Subject Addendum assessment and decision for proposed modification to S5440 - 5450 Little Creek – Tabulam Rivulet MWREF

Modification to the seg. 5440 5450 Little Creek – Tabulam Rivulet MWREF.

This memo is an addendum to and is to be read in conjunction with the approved Minor Works REF Little Creek - Tabulam Rivulet recommended by Greg Collins, Transport for NSW Environmental Manager, and approved by David Pattison, Senior Manager Project Services South, on 25 August 2022.

Figure 2a (Source: TfNSW Draft IFC design)

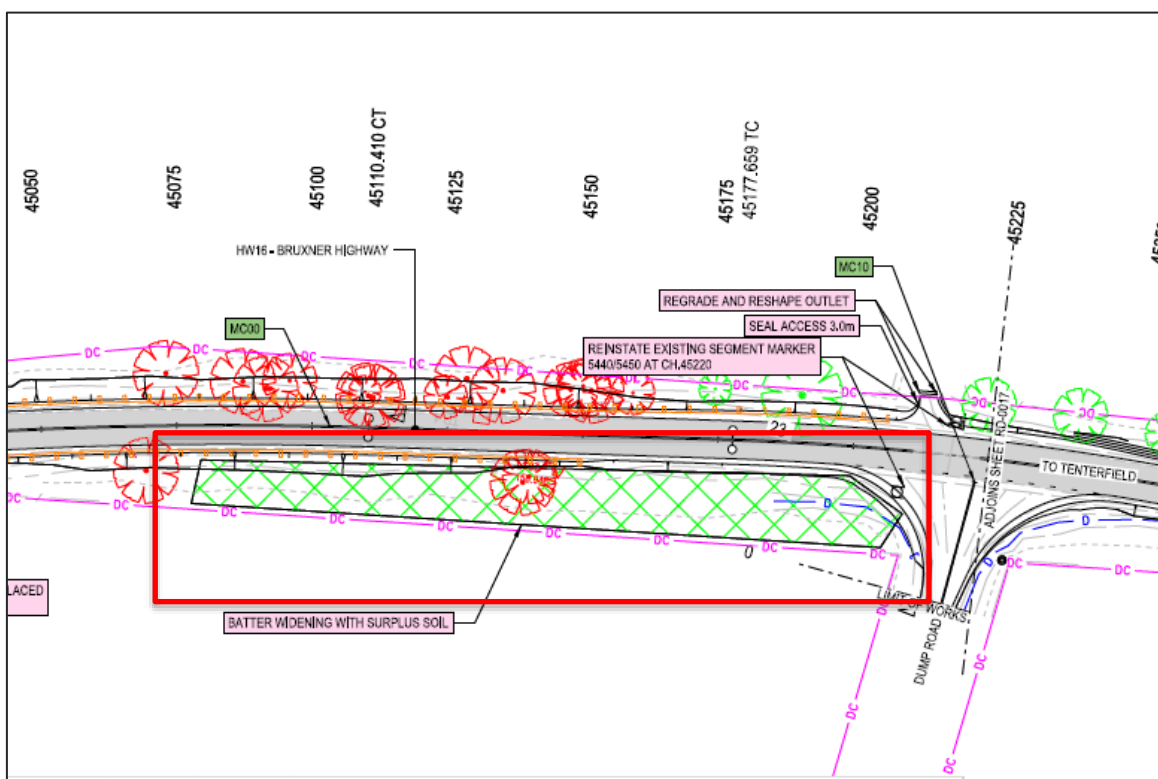
Site 1 - (depicted by the red bounded, green cross-hatched area in Figure 2a below) – located on the northern side of the Bruxner Highway east of Dump Road and extending laterally from the road formation to the fenceline/road corridor boundary. There are approximately eight (8) additional mature trees in this area not captured in the survey information but require removal so that excess spoil can be placed and finished. Removal of vegetation will also improve intersection sight distance at Dump Road.

Figure 2b (Source: TfNSW Draft IFC design)

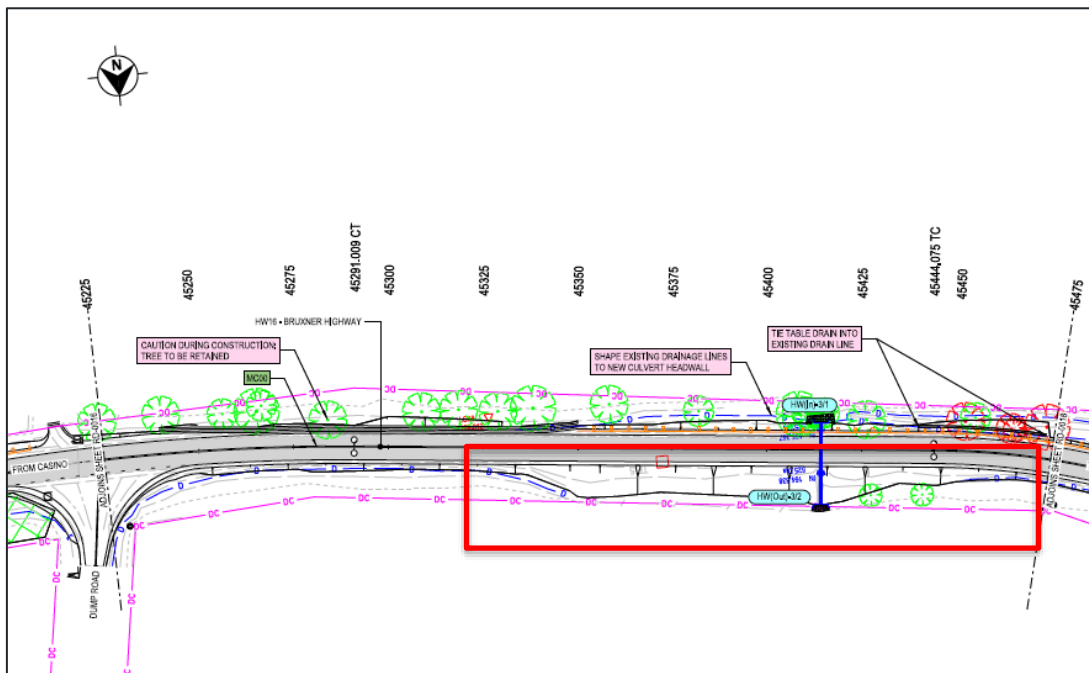
Site 2 - (depicted by the red bounded area in Figure 2b below) – located on the northern side of the Bruxner Highway west of Dump Road and extending laterally from the road formation to the fenceline/road corridor boundary. There are approximately three (3) additional smaller trees in this area not captured in the survey information but require removal so that excess spoil can be placed and finished. Removal of vegetation will also improve intersection sight distance at Dump Road and on the inside of the curve to/from the west.
